Comment Responses for the Nuclear Regulatory Commission Request for Additional Information on the Draft Waste Incidental to Reprocessing Evaluation for Waste Management Area C

Date Published
October 2019

This document provides DOE's responses to the NRC staff RAIs, to facilitate NRC's completion of a Technical Evaluation Report (TER) on the Draft WIR Evaluation. For each of the 21 RAIs, the NRC comment, basis information, and proposed path forward is quoted directly as received from NRC (with minor typographical corrections). These are followed by DOE's response. The topics discussed herein are technical in nature. Although DOE has attempted to present this information in an accessible manner, it cannot be considered a stand-alone document. The RAIs and responses are part of the on-going interaction between DOE and NRC staff regarding the review of the Draft WIR Evaluation and the associated WMA C PA, and can only be understood in that context; a working knowledge of those documents is assumed.

Figure 1. Effective Dose for Three Chronic Exposure Scenarios for a Fully Plugged Cascade Pipeline.

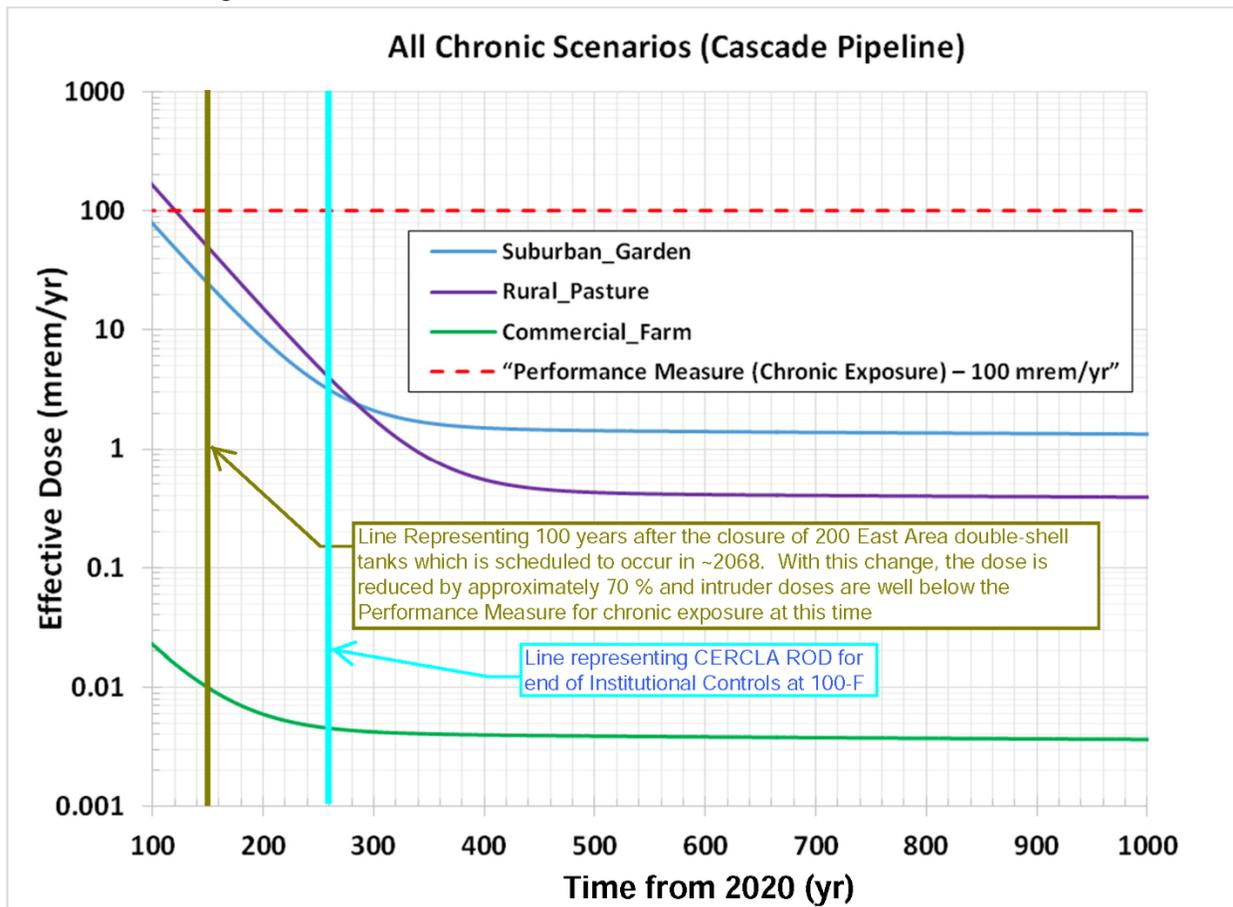
DOE indicated it would not be technically practical to remove additional waste and key radionuclides from ancillary structures. The basis for this statement was not provided for plugged pipelines. Plugged pipelines represent one of the highest risks from all of the potential structures proposed to be left in place. Removal would seem to be a viable option for plugged pipelines unless it is not technically and economically viable to do so. DOE has spent approximately \$750 million dollars to remove waste from the tank farm at WMA C (NRC's Agency-wide Documents Access and Management System [ADAMS] Accession No. ML18337A404). According to DOE's "Draft Waste Incidental to Reprocessing Evaluation for Closure of Waste Management Area C at the Hanford Site" (DOE/ORP-2018-01), [Draft WIR Evaluation], they will have removed approximately 96% of the waste from the tank farm at closure. The "Performance Assessment of Waste Management Area C, Hanford Site" (RPP-ENV-58782) [WMA C PA] shows that the waste residuals result in a dose to a member of the public of approximately 0.166 mrem/year within the sensitivity analysis period (Figure 8-22, WMA C PA) and a dose to a hypothetical acute inadvertent intruder of approximately 4 mrem (averaged over sixteen 100- and 200- series tanks). The average amount spent on removing waste from an average tank (life-cycle) would be approximately \$47 million.

Please provide a basis that it is not technically and economically practical to remove and dispose of plugged pipelines.

As the Basis section of this RAI points out, a plugged pipeline could represent a source of higher potential dose to an inadvertent intruder than other components within WMA C, suggesting that resources might be well spent in removing this source. However, this is not born out in an analysis of costs and benefits. RPP-PLAN-47559, *Single-Shell Tank Waste Management Area C Pipeline Feasibility Evaluation*, was prepared as a scoping study to support WMA C closure planning, and is a primary reference document on this topic for the WMA C PA and Draft WIR Evaluation. As suggested in the Basis section of this RAI, RPP-PLAN 47559 relies upon previous Hanford site experience in accessing and characterizing contaminated structures as benchmarks for the analyses for WMA C. RPP-PLAN-47559, Section 7.3.1, provides a detailed examination of the costs, risks, and benefits of characterizing or removing waste transfer pipelines, and concludes that “further pipeline characterization or supplemental closure actions for protection of human health and the environment are not necessary when risks are balanced against the high cost and schedule impacts associated with these actions.” Several key points in the report which support this conclusion are summarized below.

The first two of these assumptions are critical to the dose calculation. However, the 2020 closure date assumed in the WMA C PA was based upon the then-current milestone for closure of WMA C. This milestone date is currently under negotiation by the parties to the *Hanford Federal Facility Agreement and Consent Order* (Ecology et al., 1989), also known as the Tri-Party Agreement. Furthermore, there is no planned date at which DOE expects to relinquish control of the Hanford site. There are many projects and activities that will continue at the Hanford site, including in the vicinity of the tank farms, well beyond the closure of WMA C; for example, retrieval and closure of the 200 East Area double-shell tanks (DSTs) are currently expected to continue until approximately 2068⁴.

Within 100 years of the time such activities in the 200 East Area are expected to be complete, the potential dose to the hypothetical chronic intruder (from the pipelines assumed to be plugged) will be significantly reduced, due primarily to decay of Sr-90 and Cs-137 whose half-lives are 28.8 and 30.2 years, respectively. To illustrate, assuming completion of activities in the 200 East Area in 2068 and assuming the hypothetical human intrusion occurs 100 years later (i.e., in 2168), the dose from inadvertent intrusion into a full cascade line would be reduced by approximately 70 percent due to radioactive decay of Sr-90 and Cs-137. Thus, the previously-calculated 160 mrem/year dose would be reduced to below 50 mrem/year, which is well below the DOE performance measure (100 mrem/year) for the chronic exposure scenario. To illustrate these results graphically, Figure 9.15 from the WMA C PA is reproduced below as Figure 1, with vertical lines added to illustrate the hypothetical dose result at various assumed intrusion dates. Given these considerations, the hypothetical net benefit of removing “plugged” pipelines is significantly reduced.

Also, the hypothetical “plugged pipeline” described in the WMA C PA is assumed to be completely filled with waste solids along its entire length (Section 9.5 of the WMA C PA). This provides a bounding estimate of waste inventory. While this is useful for estimating dose and exposure risk to the public and inadvertent intruders, it can be misleading in terms of closure planning. No actual pipeline is thought to be “fully filled” with residual waste solids as this hypothetical “plug” would suggest. Therefore, the benefit from removal of “plugged” pipeline segments, even if they could be identified, would be less than the assumed inventory values would suggest.

Figure 2. Tank 241-C-105 Retrieval Slurry Loading (RPP-RPT-60717, Figure 2-4).

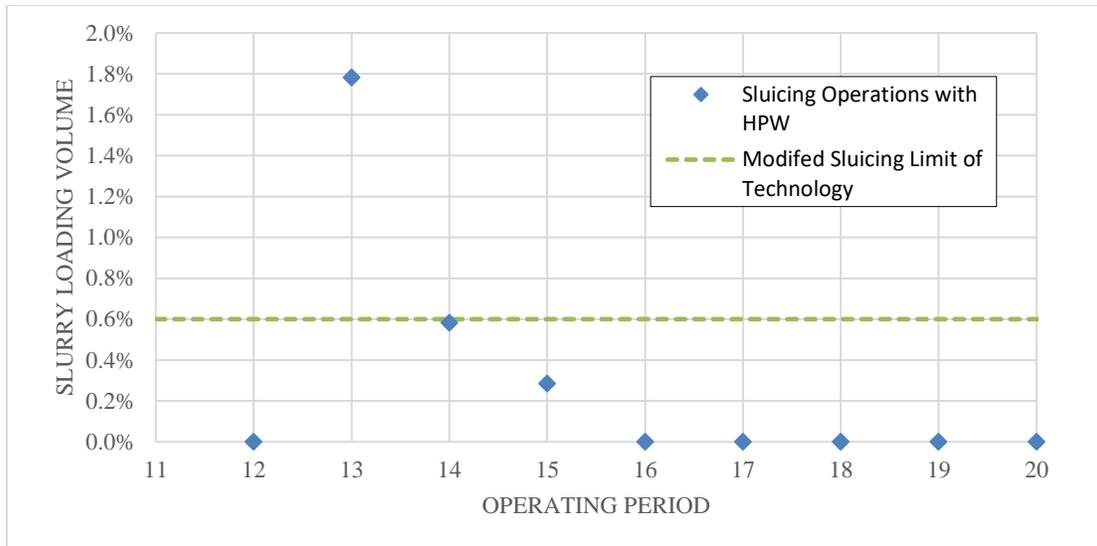
Please provide removal efficiency charts for tanks C-105, C-106, C-109, C-111, and C-112. Provide the removal efficiencies of key radionuclides Cs-137, Sr-90, I-129, Tc-99, U-isotopes, Pu-isotopes, Am-241, Np-237, and C-14, non-decay corrected. Address the additional observations noted above associated with particular tank cleaning campaigns.

The first retrieval technologies deployed in Tank C-105 were the Mobile Arm Retrieval System – Vacuum (MARS-V), including high-pressure water (HPW) sluicing, which operated from September 2014 to September 2015. MARS-V was effective in removing approximately 75 percent of the starting waste volume. No efficiency charts were developed for this stage of retrieval. The campaign ended due to equipment failure.

In 2017, MARS-V was replaced with an Extended Reach Sluicer System (ERSS), to be used with caustic dissolution. Supernate and HPW sluicing was conducted intermittently with caustic dissolution cycles starting in August 2017. ERSS sluicing operations with high pressure water were terminated in Tank C-105 on October 20, 2017. At that time, operations had continued for five consecutive periods without being able to retrieve any additional solids. Figure 2-4 from RPP-RPT-60717, *Retrieval Completion Certification Report for Tank 241-C-105*, reproduced below as Figure 2, depicts the slurry loading per operating period from October 14, 2017 to October 20, 2017 (operating periods 15 to 20). The dashed line represents the 0.6 volume percent limit specified in RPP-50910, *Single-Shell Tank Waste Retrieval Limit of Technology Definition for Modified Sluicing*.

Figure 5. Tank C-109 Modified Sluicing Waste Retrieval System Performance.
(from DOE/ORP-2018-01, Figure 4-21)

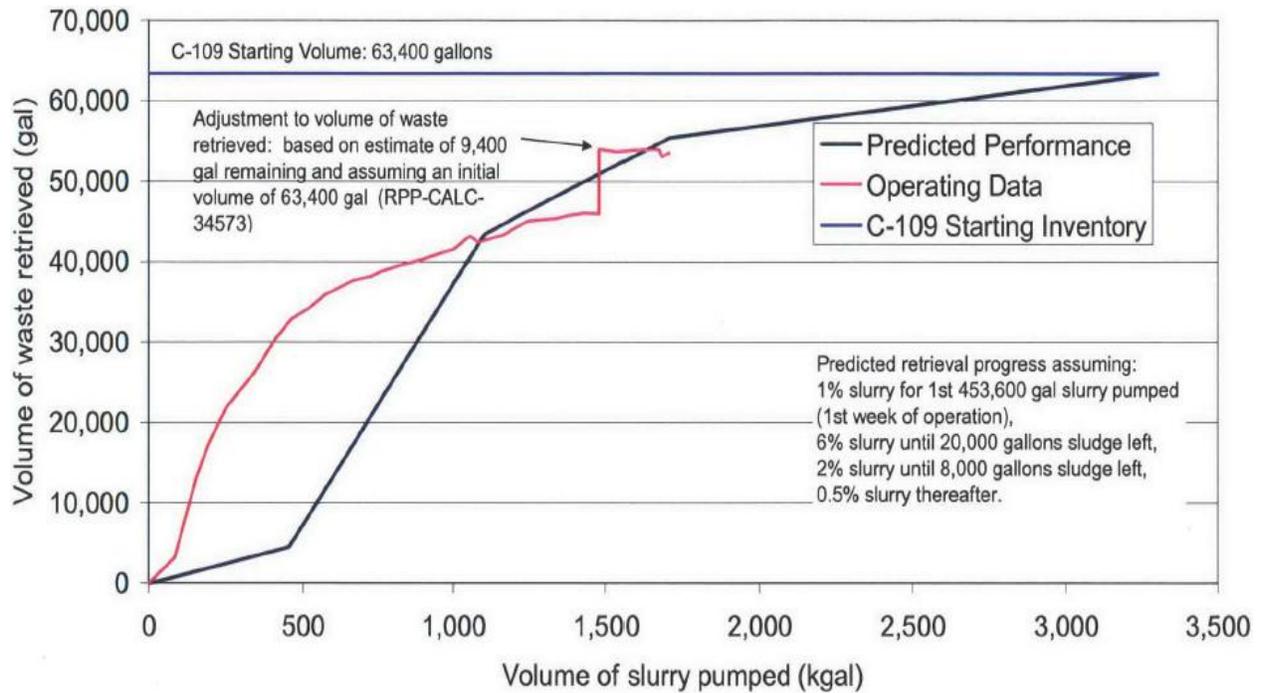
- For Tank C-109, Figure 4-22 does not appear to shown decreasing effectiveness of the technology with time. The fluoride concentration increases with circulation time. Longer circulation time should correspond to more waste removal.

Waste retrieval in Tank C-109 consisted of three campaigns: modified sluicing, a FoldTrack MRT demonstration, and caustic dissolution. Sluicing began in June 2007 and reached the limits of technology in August 2007. Figure 4-21 from the Draft WIR Evaluation, reproduced below as Figure 5, depicts removal efficiency for sluicing, which removed approximately 85 percent of the starting waste volume.

Although the fluoride concentration appears to be increasing as indicated in Figure 4-22 in the Draft WIR Evaluation, this is an artifact of the limited number of points on the graph. The reaction had gone to completion prior to the final sample. Section 2.4.2 of RPP-53824, *Retrieval Completion Certification Report for Tank 241-C-109*, provides the following explanation:

Figure 12. Location of Groundwater Wells Surrounding WMA C.

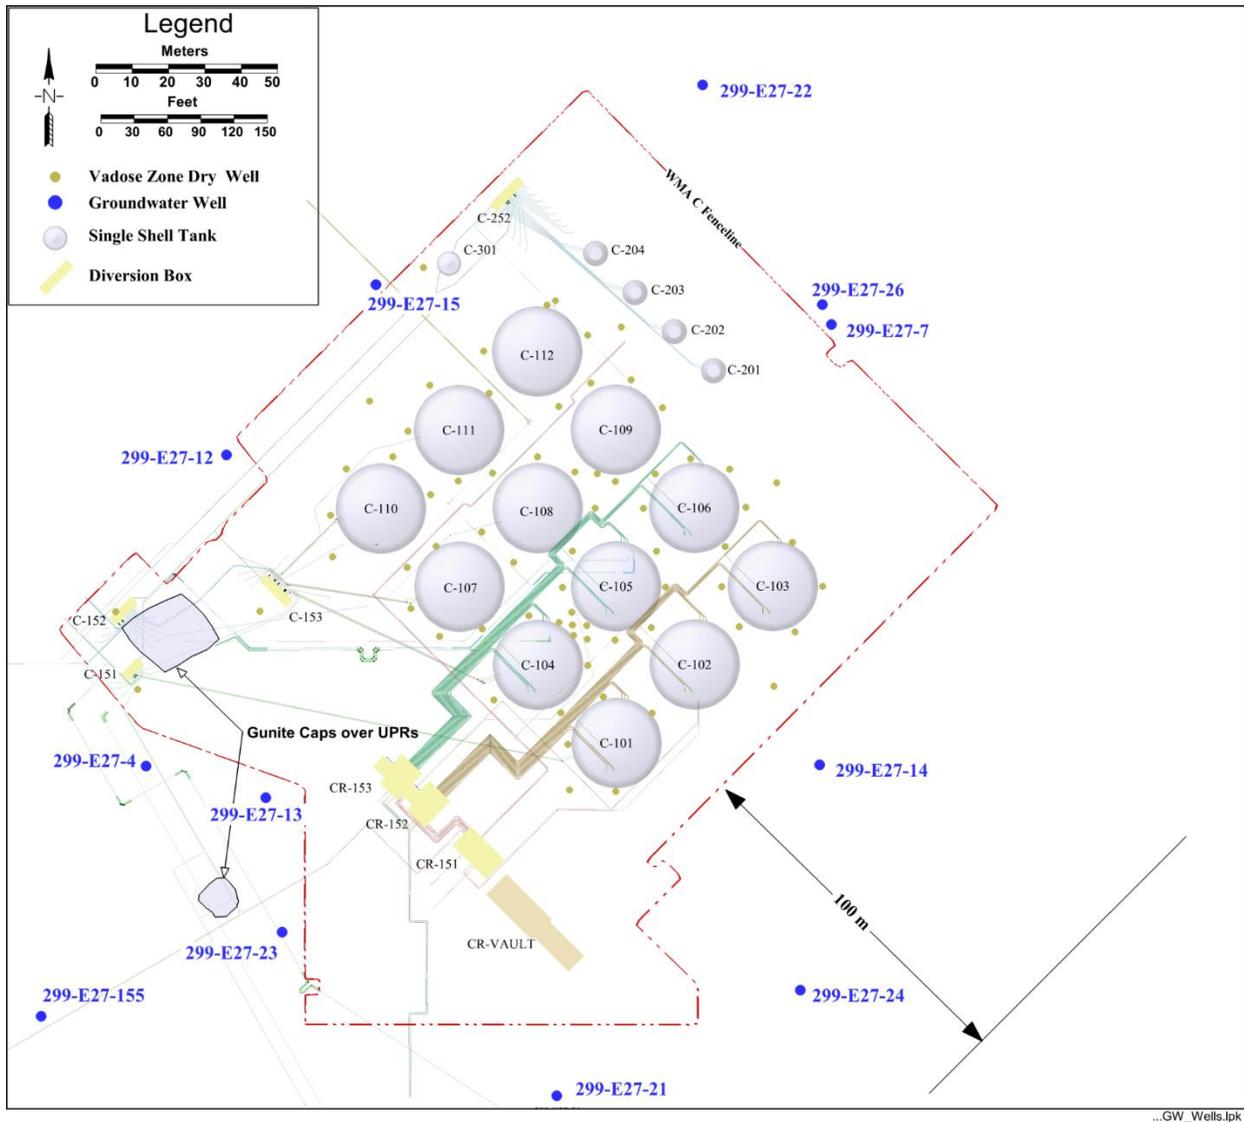
As shown in Figure C-6 of the WMA C PA, until recently, most DOE documents and sources provided a range of hydraulic conductivity values that were lower than the current average WMA C PA value of 11,000 meters per day (m/d). Previously, RPP-RPT-46088, Revisions 0, 1, and 2 (in Section 5) had given the general range of saturated hydraulic conductivity values for the unconfined aquifer as between 1000 to 3000 m/d with a recommended parameter value of 3000 m/d and using a recommended minimum and maximum of 100 m/d and 7000 m/d, respectively (RPT-46088, Rev. 1).

The geologic descriptions given for the twelve groundwater monitoring wells (See Figure 12) surrounding WMA C indicates the unconfined aquifer beneath WMA C resides wholly within buried paleochannels containing high-permeability flood gravels (Bjornstad and Last, 2007, “Effects of Ice Age Flooding on the Hydrogeology of the Hanford Site”).

Five of the twelve groundwater monitoring wells were drilled in the 1980s (Well No. 299-E27-7, 299-E27-12, 299-E27-13, 299-E27-14, and 299-E27-15). Well Construction and As Built Reports are the only available data which describe the geology for each of these monitoring wells. These reports indicate gravel to sandy gravel to muddy, sandy, gravel within the unconfined aquifer. Of these five early wells installed in the 1980s, only one report for Well No. 299-E27-7 which was installed in 1982 calls out the Ringold formation which is known to occur approximately 16 to 20 ft below the water table surface. [Note: geologic logs for these specific wells were prepared before the site standards for describing the geology were developed; thus, these logs may not have been performed by a registered geologist].

**Figure 14. Plan View of the Central Plateau Groundwater Model
Waste Management Area C Flux Calculation Window.**

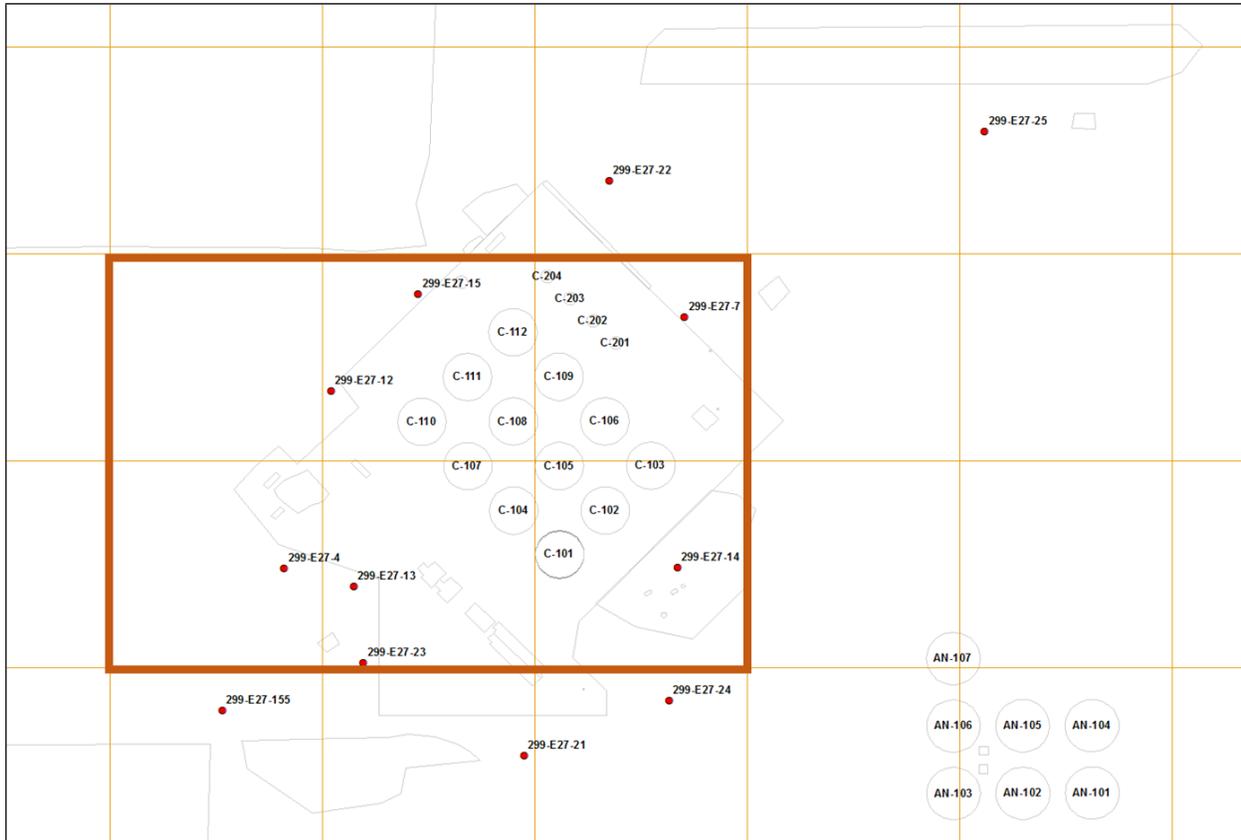
Additional information is needed on the approach for deriving groundwater flux for use in the STOMP model. By evaluating the water budget in the CPGW model through a planar rectangular window similar to the WMA C flow domain over the unconfined aquifer thickness, a Darcy flux is estimated. This CPGW model volumetric flux calculation window does not align with the orientation of the northern boundary of the WMA C STOMP model used in the WMA C PA (Figure C-5 in the WMA C PA). It is not clear how much this misalignment influences the groundwater flux estimate since the greater the angle of misalignment the less realistic the flow estimate will become.

The overall approach for evaluating dilution in the performance assessment has been specifically designed to maintain consistency with the amount of aquifer dilution that would be estimated by the Central Plateau Groundwater Model (CPGWM), CP-47631, 2015, *Model Package Report: Central Plateau Groundwater Model Version 6.3.3*. The aquifer boundary conditions approximate the Darcy flow rates in the aquifer in the area around WMA C produced by the CPGWM (Figure 14). The hydraulic gradient is specified to support these flow rates, and the hydraulic conductivity is assumed to equal the average of the CPGWM values.

The CPGWM rectangular calculation window is 300 m × 200 m (980 ft × 660 ft) and with a depth of 11 m (36 ft), and the volume encompasses most of WMA C (Figure 14). The effective hydraulic conductivity for the equivalent homogeneous medium (EHM) model is the average of the CPGWM

Figure 16. Structure of Uncertainty Analysis (after NCRP, 2005).

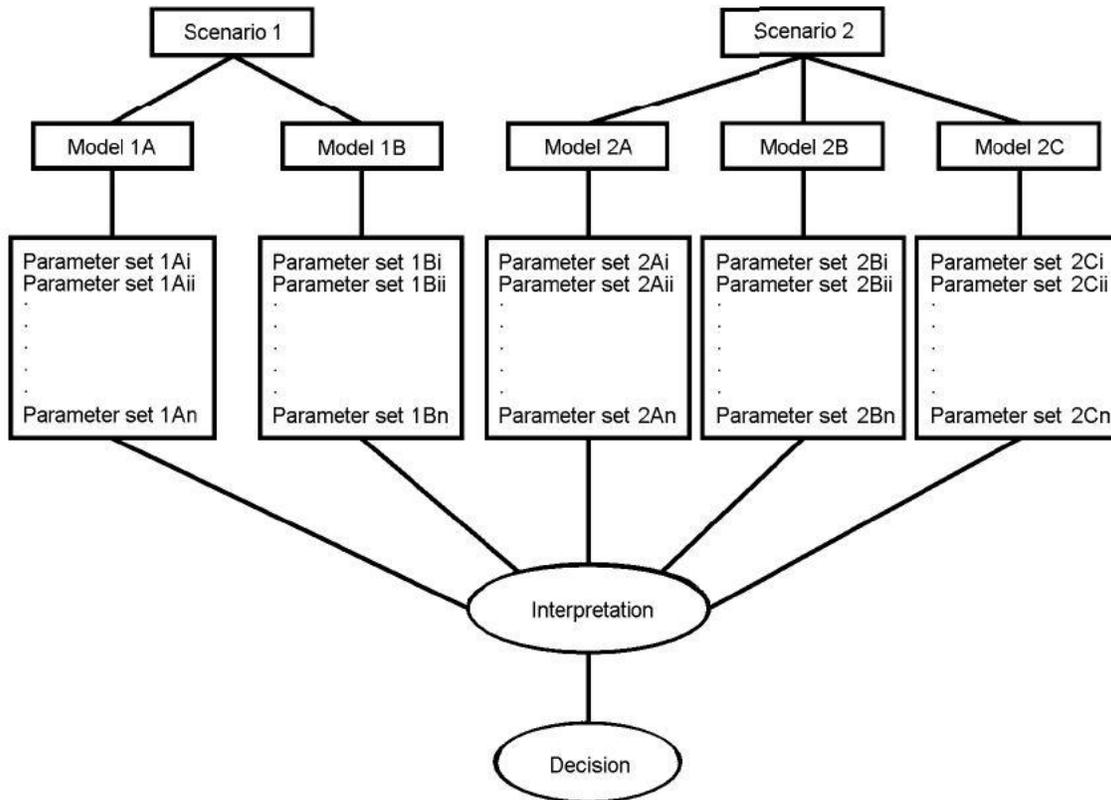
The uncertainty analysis appears to be focused on the evaluating the range of variability of the input parameter values for the base case and is not able to identify plausible alternative conceptual models. An assumption that there is only one plausible future scenario (i.e., no alternative future scenarios) with a non-dynamic environment for 10,000 year requires a rigorous technical basis. Results of analyses should evaluate the interdependencies and interrelationships between components of the system and provide supporting evidence of plausible alternative scenarios or conceptual models.

The Basis section of this RAI suggests a misunderstanding of DOE's framework for evaluation of uncertainties. This response will clarify the significance of the approach to uncertainty, and how it addresses the overall uncertainties of concern in this RAI. Additional information on the framework for identifying sensitivity analysis cases and their significance in the WMA C PA is presented in the DOE response to RAI 2-2.

An overall analysis of uncertainties in performance assessment have long been regarded as comprising three types: future (or scenario) uncertainties, model uncertainties, and parameter uncertainties (NCRP Report 152, "Performance Assessment of Near-Surface Facilities for Disposal of Low-Level Radioactive Waste"). A structure of such an overall analysis is shown in Figure 16. A performance assessment generally needs to address these three types of uncertainty to provide adequate information to decision makers.
